2024.1.31

TITLE: Sheet_1		REV: 1.0
嘉立创EDA	Company: Your Company	Sheet: 1/1
	Date: 2023-11-09 Drawn By: Denjhang

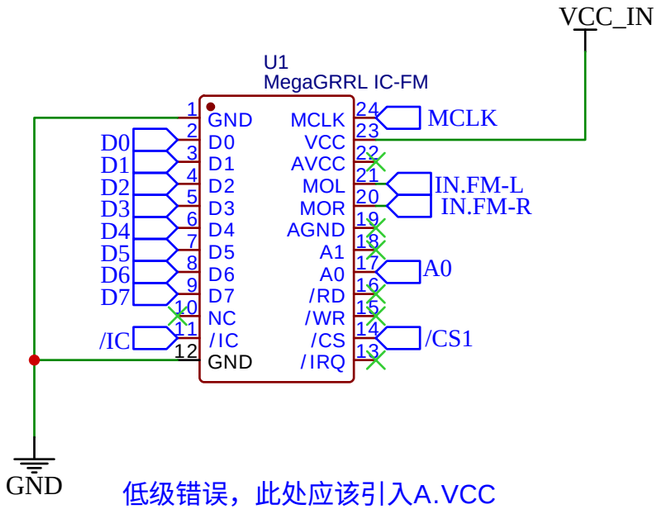
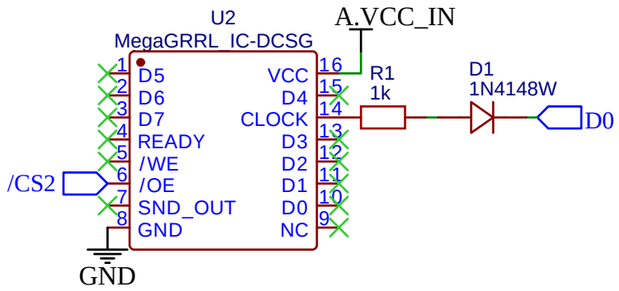
低级错误，此处应该引入A.VCC

1.修复A.VCC

2.删除多余的二极管

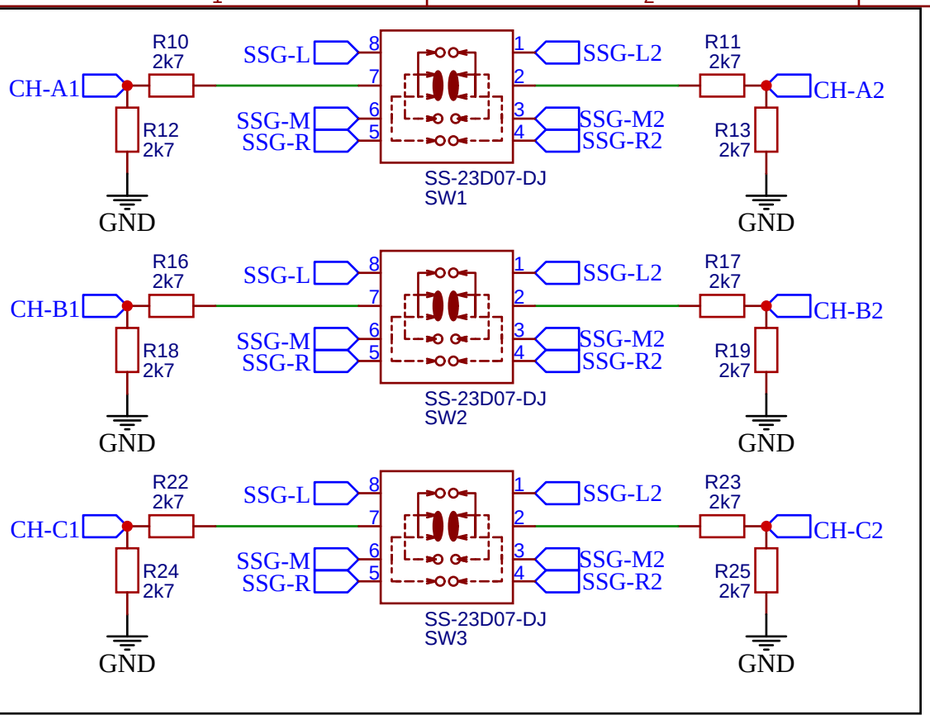
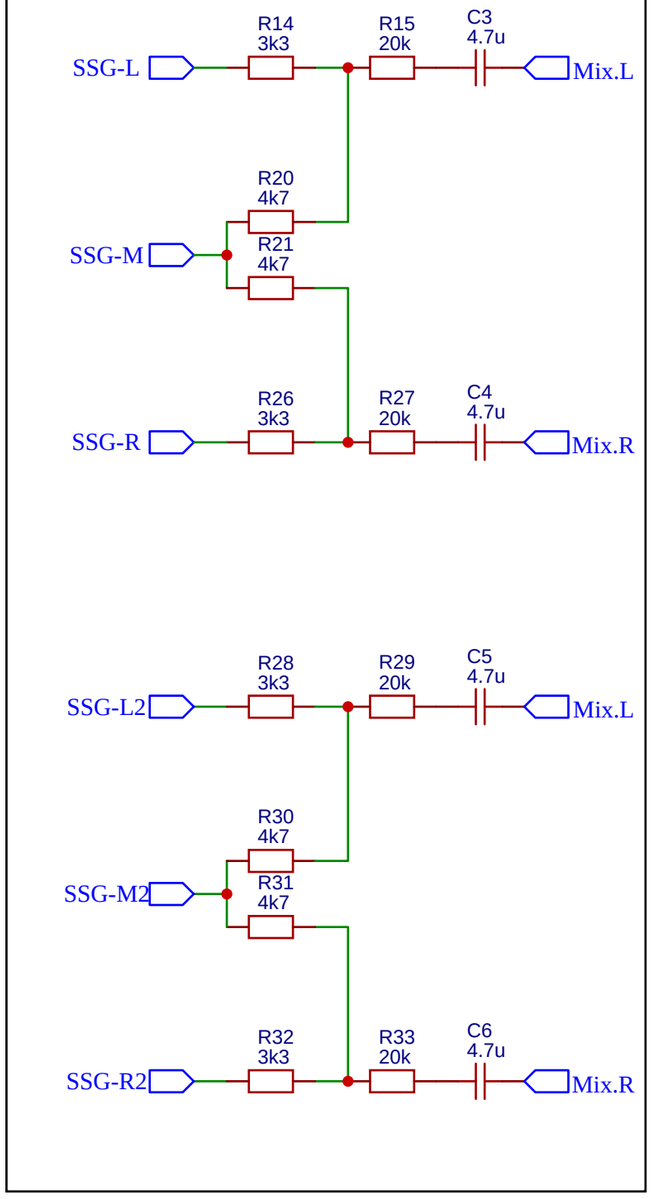
目前中声道声音偏小，可以左右电阻加到3k3

省略一级混音缓冲放大器

SSG在过下拉电阻之前，禁止接电容

此处参考RC2014-YM2149的黄金比例立体声混音
